BID ADDENDUM NO. 1
TO
CONTRACT DOCUMENTS
AND
TECHNICAL SPECIFICATIONS
FOR
POOL LOCKER ROOM RENOVATIONS
AT
HOMMOCKS MIDDLE SCHOOL
NYSED #66-07-01-03-0-011-031

Mamaroneck Union Free School District
1000 West Boston Post Road
Mamaroneck, NY 10543

LAN Job #4.1092.87
September 13, 2024

FLOOR SLAB TRENCHING PLAN

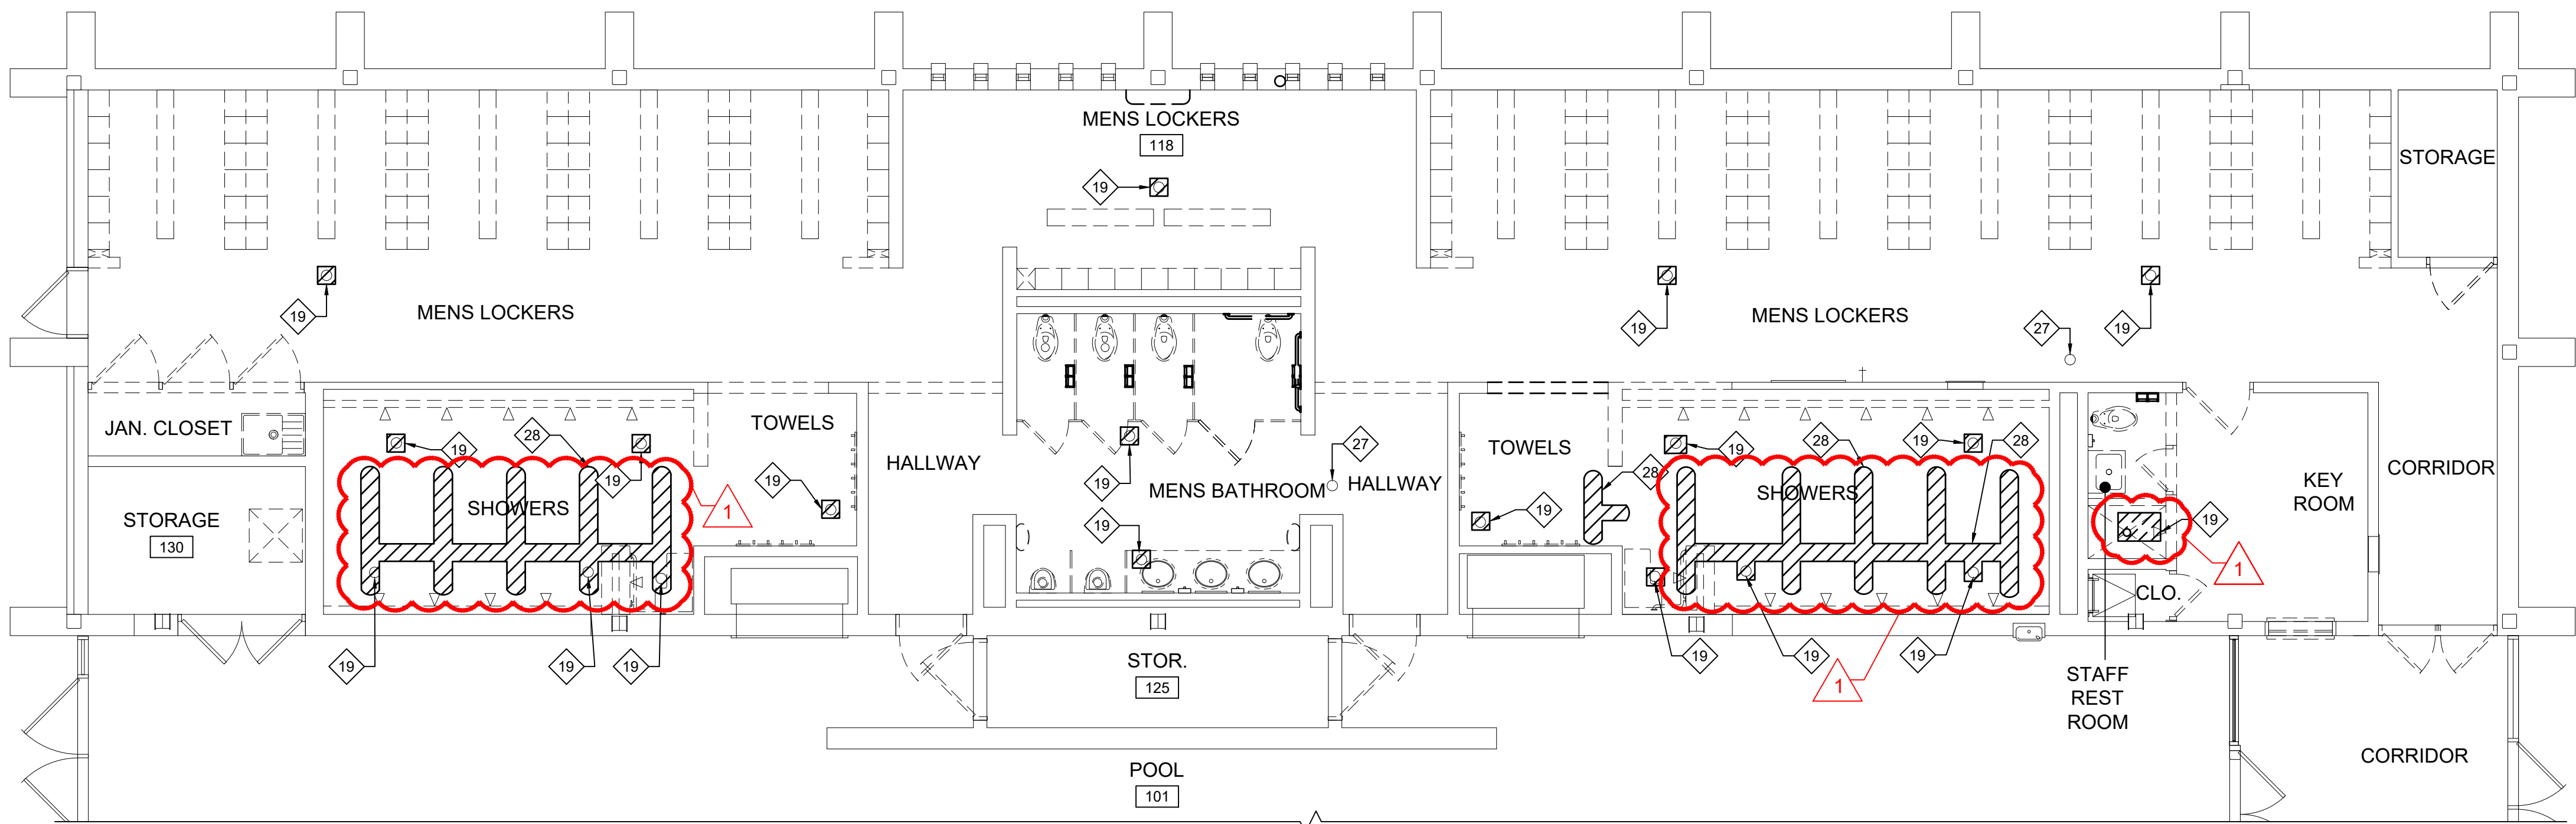
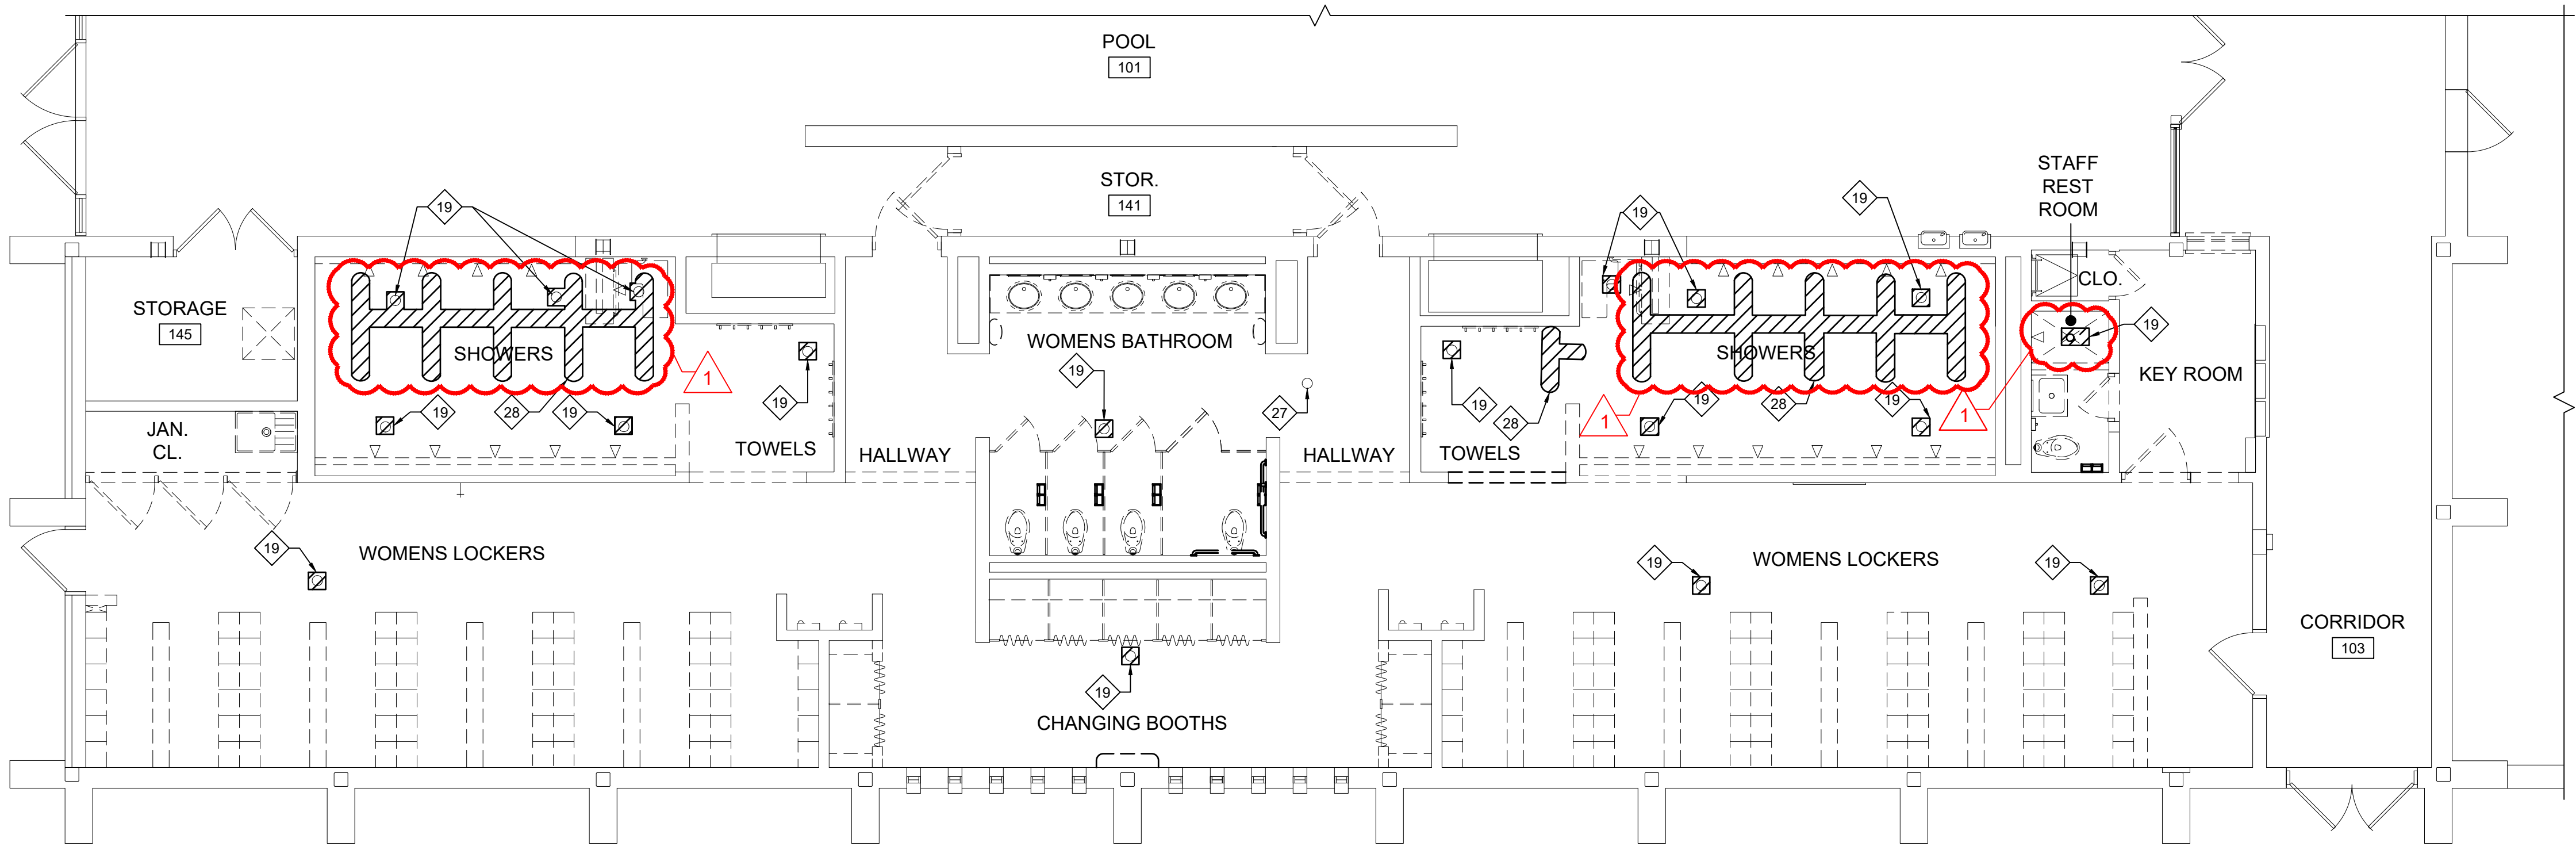
No.	Comment/Response
22	<p>Comment: Please provide spec for Kalwall skylight system.</p> <p>Response: Specification added to this addendum.</p>
23	<p>Comment: Please provide Hardware spec and schedule for the doors.</p> <p>Response: See response to comment #1</p>
24	<p>Comment: Please provide a specification for the Kalwall skylight depicted on drawing A6.05.</p> <p>Response: See response to comment #22</p>
25	<p>Comment: Who is responsible for chopping concrete?</p> <p>Response: The GC is responsible for the chopping of the concrete.</p>
26	<p>Comment: Who is responsible for backfilling and patching concrete?</p> <p>Response: The GC is responsible for backfilling and patching the concrete.</p>
27	<p>Comment: Who is responsible for removing the demoed material and existing piping once its disconnected?</p> <p>Response: PC shall demo existing piping once it is disconnected. Where areas of trenching occur and below slab piping is to be removed, GC to trench, pc to disconnect and remove piping. PC to install new piping where required, and GC to backfill and patch slab.</p>

Proposed Men's Locker Room RCP

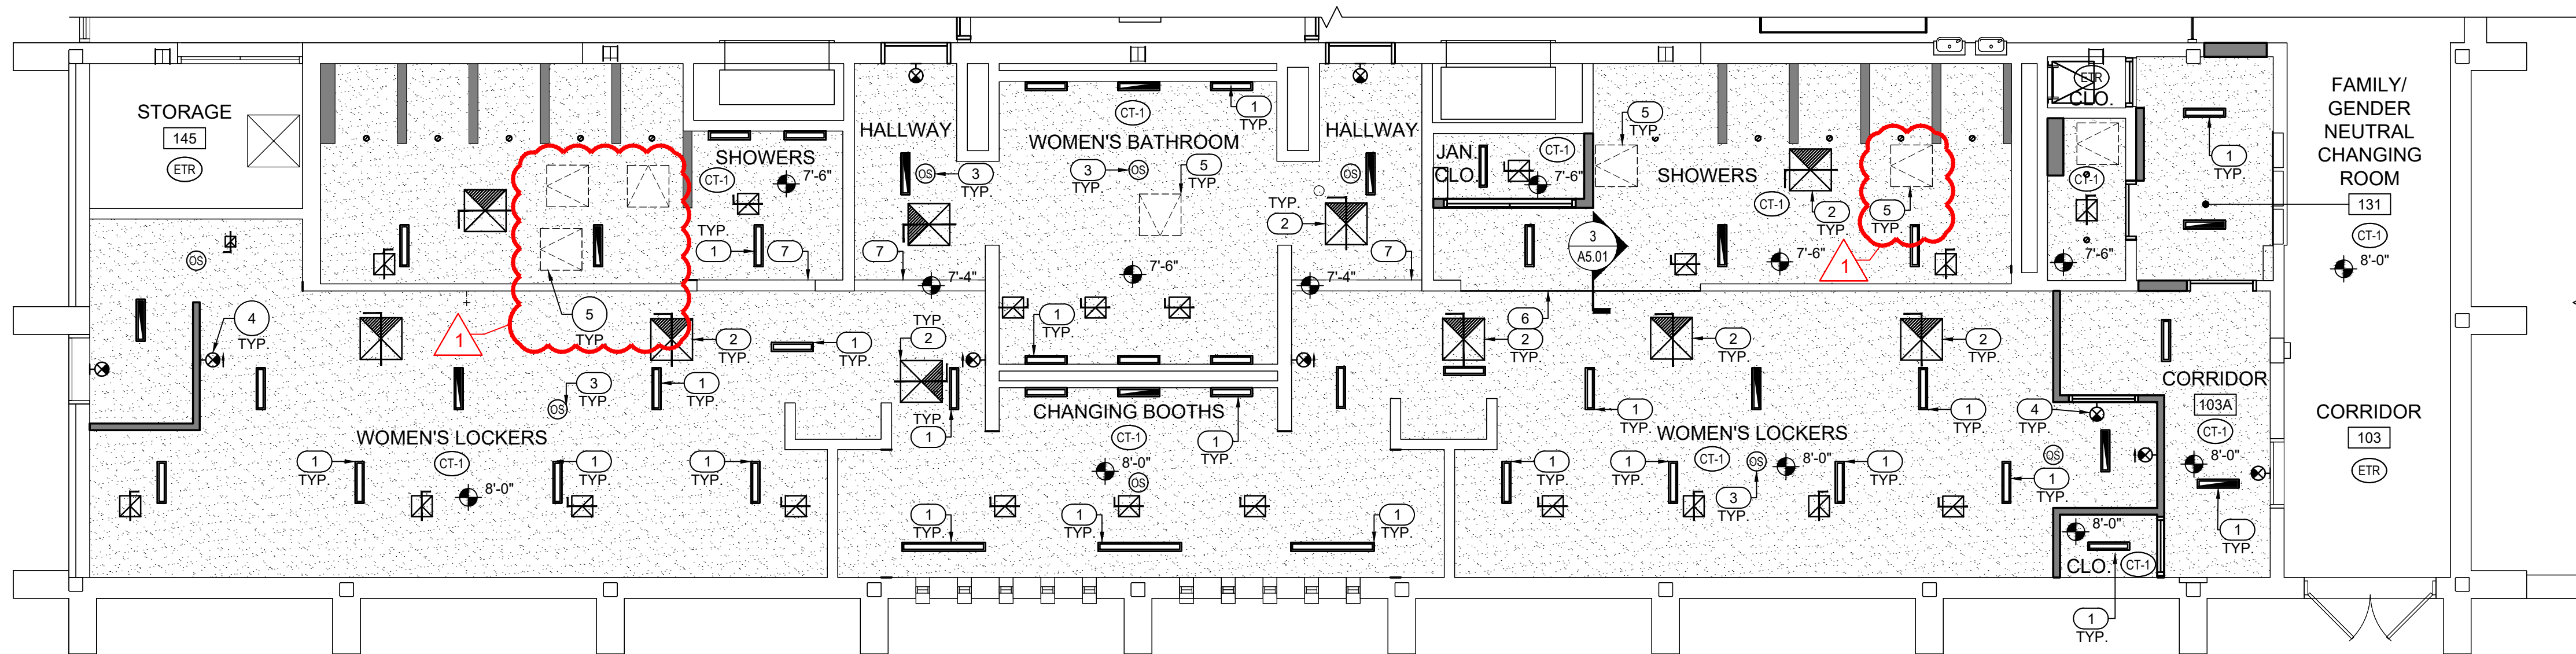
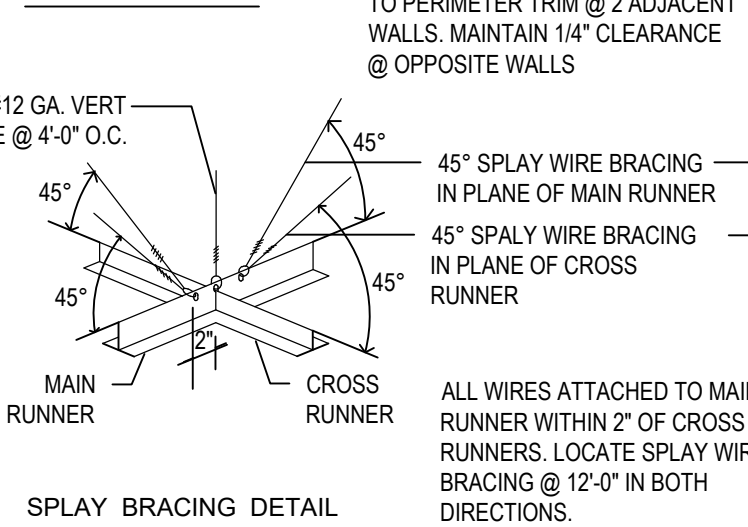
A5.01	<u>Drawing A5.01:</u> The revision includes changes to the locations of the ceiling access panels.
A6.01	<p><u>Drawing A6.01:</u> The revision includes the addition of doors D16, D17, D18, D19, D20, and D21.</p> <p>Addendum #2 will include information on door hardware.</p>
A6.02	<p><u>Drawing A6.02:</u> The revision includes changes to the height of door type 'A' and 'B'.</p> <p>Drawing revision includes the addition of door types 'C' and 'D'. Door types 'C' and 'D' will be used for doors D17, D20 and D21. When the existing frame is removed, and the new frame is installed, the opening above will be infilled with wall type A1.</p>
A6.03	<p><u>Drawing A6.03:</u> The revision includes changes to detail 7/A6.03 which show the new pre-manufactured shower pan and shower diverter valve control handle.</p> <p><u>Drawing A6.03:</u> Details 1&3/A6.03 updated to indicate new solid grouted CMU locker bases.</p>
